AP - 057

**GENERAL
CORRESPONDENCE**

From: Griswold, Jim, EMNRD
Sent: Wednesday, July 02, 2008 10:03 AM
To: Cliff Brunson (cbrunson@bbcininternational.com)
Subject: AP-57, Hess Corporation, State G Battery
Attachments: AP-57 new wells.pdf

AP-57: Texaco New Mexico "G" State Battery #22

New Well Locations

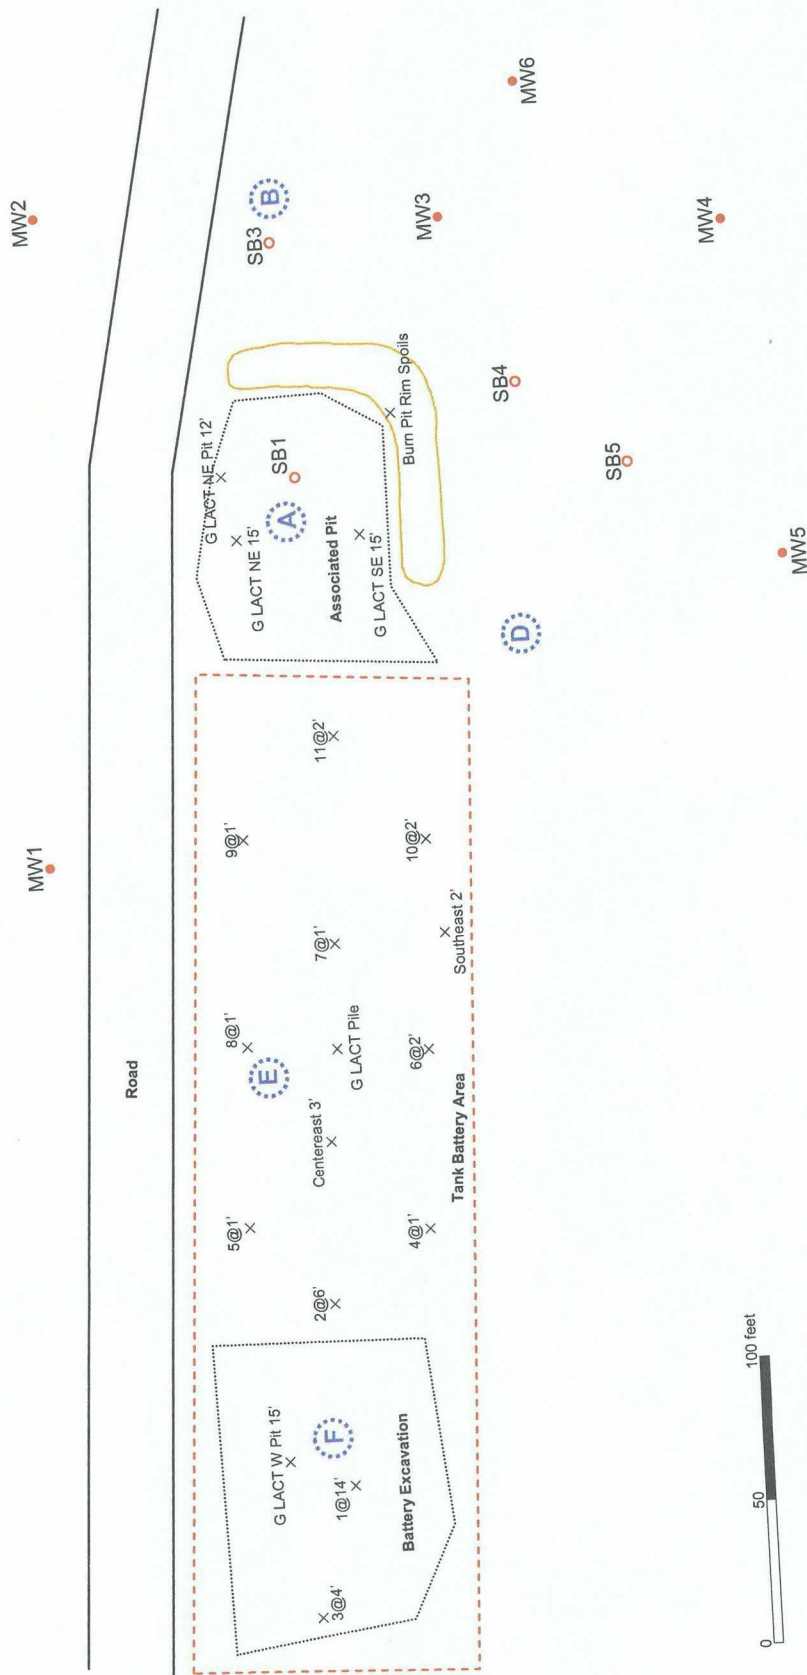
Sufficient information has not been gathered that would allow for the design of an effective remedial strategy. Further assessment is necessary. I have attached a site map identifying six locations where additional monitoring wells need to be installed:

Location A is in the former associated pit. This is the likely area of highest contamination.

Location B is east of SB3 and is based on observed levels of adsorbed-TPH and -chloride in the vadose zone soils along with indications of LNAPL on the water table.

Location C is downgradient of MW6 and MW4. The level of dissolved hydrocarbon in those wells are low, but they contain the highest measured concentrations of chloride and manganese.

Location D is to the south-southwest of the associated pit. This well will help define the lateral extent of both soil and groundwater contamination cross-gradient from the former associated pit. This location is also justified based on the amount of TPH previously assayed in soils from SB5 at or near the water table.

Location E is within the "tank battery area" and is included based on historic soil data from sampling locations 5, 8, and 9.

Location F is within the battery excavation, another potential source of groundwater contamination.

Representative soil samples should be gathered using splitspoon samplers at five foot intervals beginning five feet below surface and continuing to the water table in each new boring. Each of the soil samples should be field screened for headspace and chloride. At least two soil samples from each bore should be split for laboratory analysis (even if they appear grossly contaminated) by Method 8260B, Method 8310, Method 8015B (GRO and DRO), Method 418.1, Method 6010B/6020 for RCRA and WQCC metals including mercury by Method 7470/7471, along with general chemistry by methods described in 40 CFR 136.3 to include chloride, fluoride, calcium, sodium, potassium, magnesium, bicarbonate and carbonate alkalinity, sulfate, nitrate, phosphate, and bromide. Clean cuttings can be spread at the site. Contaminated soils should either be containerized and disposed or placed on sheet plastic within a berm for later disposal.

Groundwater monitoring wells should be completed at each of the six bores incorporating no more than 15 feet of screen set to span the water table (approximately 10 feet into groundwater with 5 feet above the water table). Each well should be developed of fines after installation and allowed to stabilize at least 24 hours before undertaking groundwater sampling. Development water needs to be contained and properly disposed. The top-of-casing elevation of each new well needs to be established to an accuracy of 0.01 feet and the basemap updated.
